APPENDIX Q

RE: Electric Owl Holdings, LLC: Petition to Amend the Code of the Village
Supplemental Submission
Subject Premises: One South Broadway, Hastings-on-Hudson, New York

Comments from September 21, 2023 Joint Meeting and Applicant's Responses:

DRAWING NO: **L 3.0**
SITE SECTIONS A

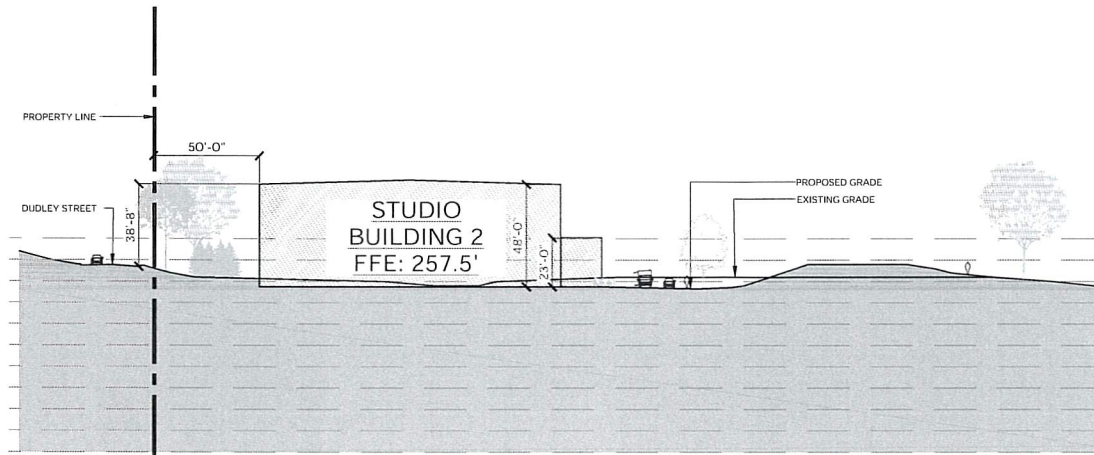
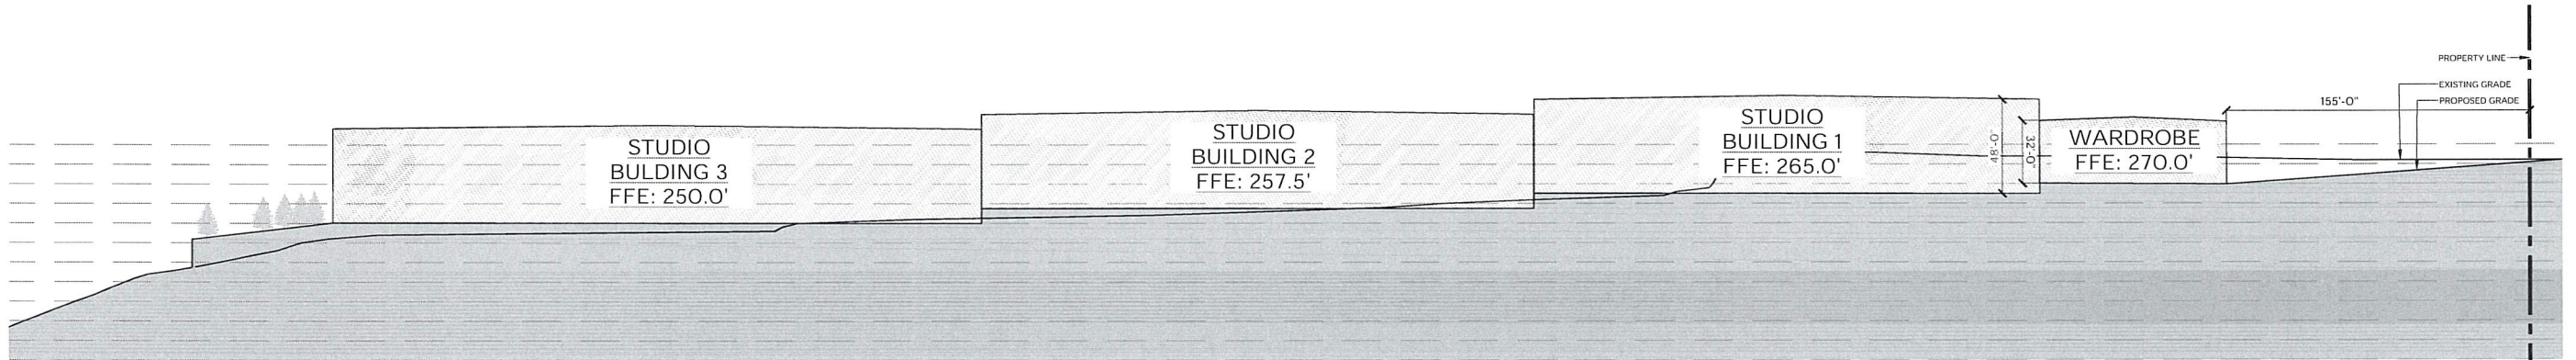
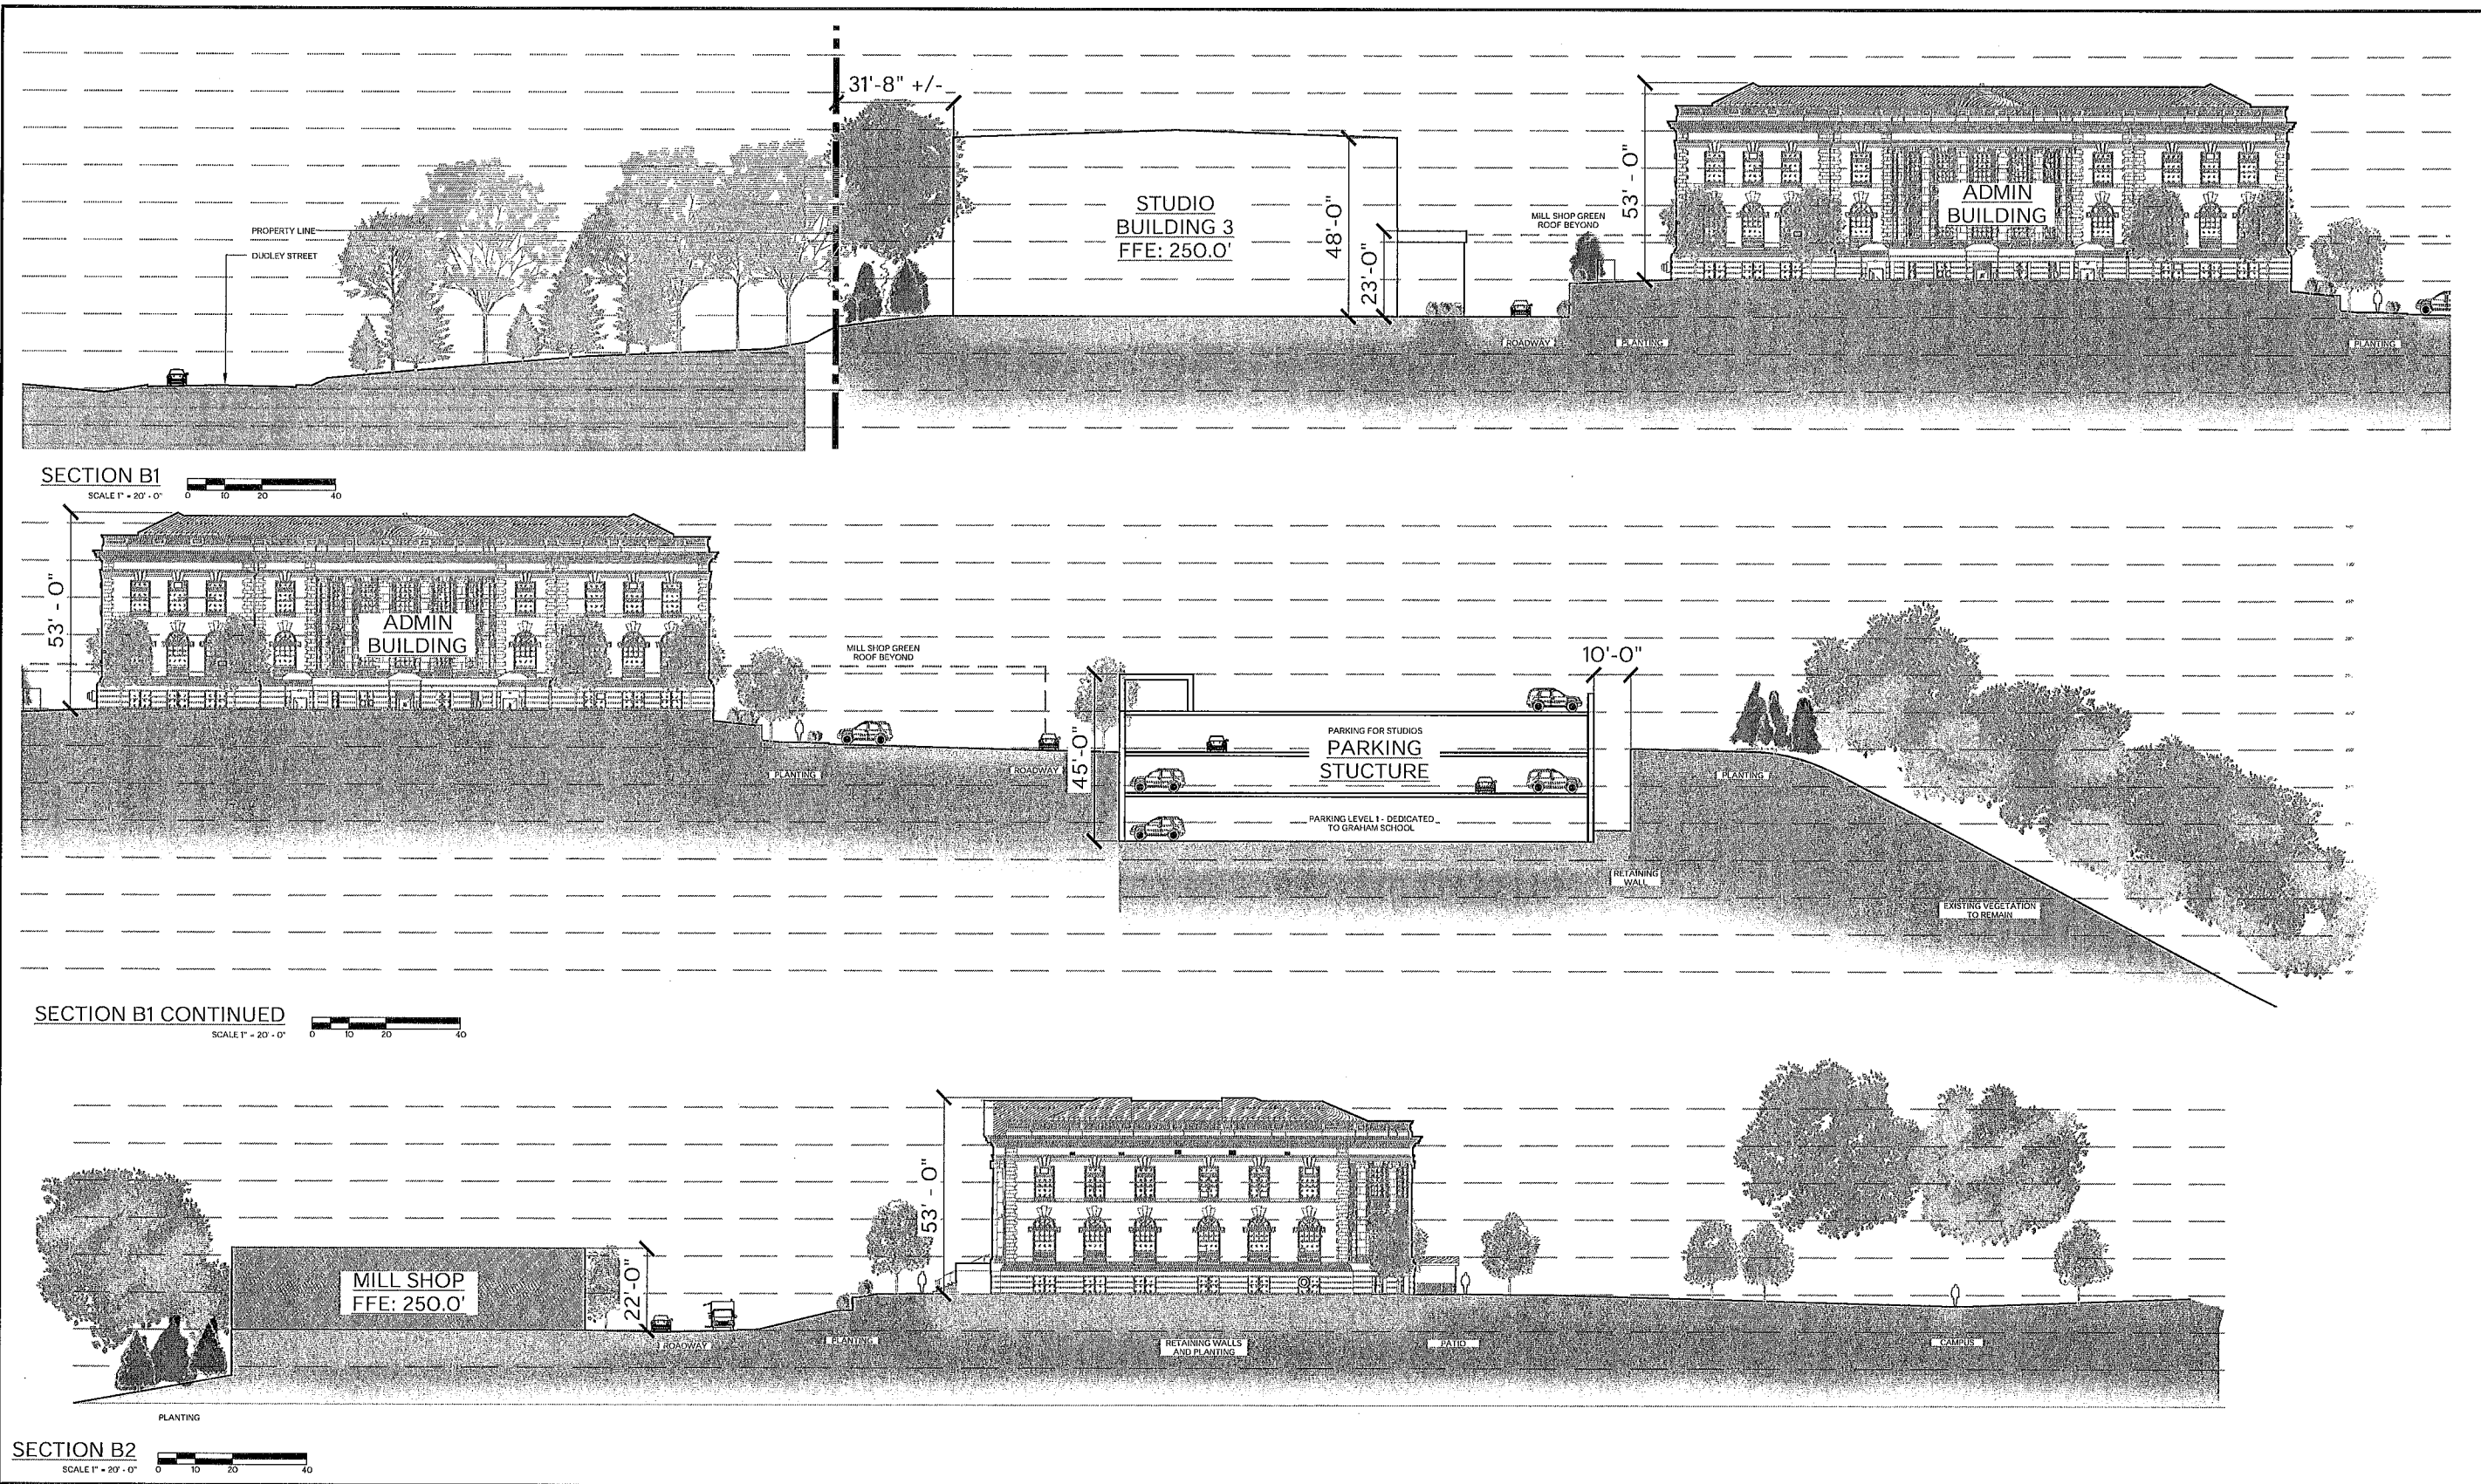
4. ***Can further architectural information be provided, such as Sections to show adjacent grades to better enable an understanding of the full height of the studio walls as viewed from the south? It would help to have perspectives looking down from Dudley Street from Broadway, back up, and from the Lenoir Preserve parking lot toward the Studios.***

Additional architectural plans are enclosed, including those prepared to respond to these Sections to show the grade difference between Dudley Street entitled, "Electric Owl Studios, 1 S. Broadway, Hastings on Hudson, NY," prepared by Granoff Architects, dated October 30, 2023, consisting of the following sheets:

- a. (L.3.0) "Site Sections A"
- b. (L.3.1) "Site Sections B"
- c. (L.3.2) "Site Sections C"
